Access Compliance Report Public Rights-of-Way (Curb Ramps)

Main Street: GLENDALE_DR Cross Street: CRESTKNOLL_DR Location: SW

ADA ID: RPAT210923091230 Ramp Type: Type 4 - Parallel Initial Pass/Fail: Fail Overall Compliance: No Severity Score: 15

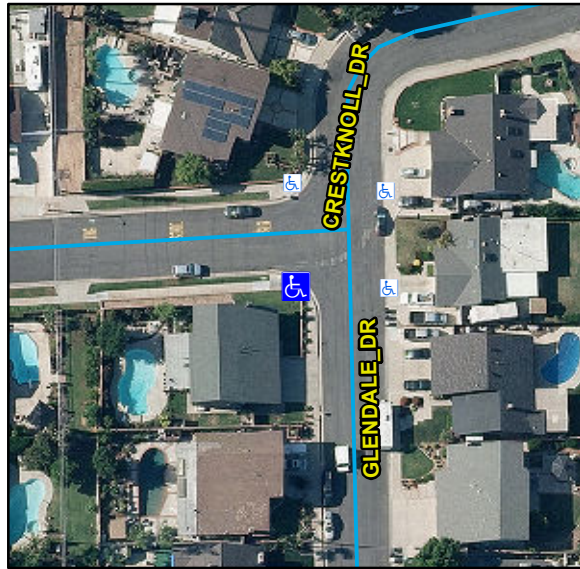
R304.3.2, STD 1115

Remove & Replace Curb Ramp With Two New Directional Ramps or Equivalent.
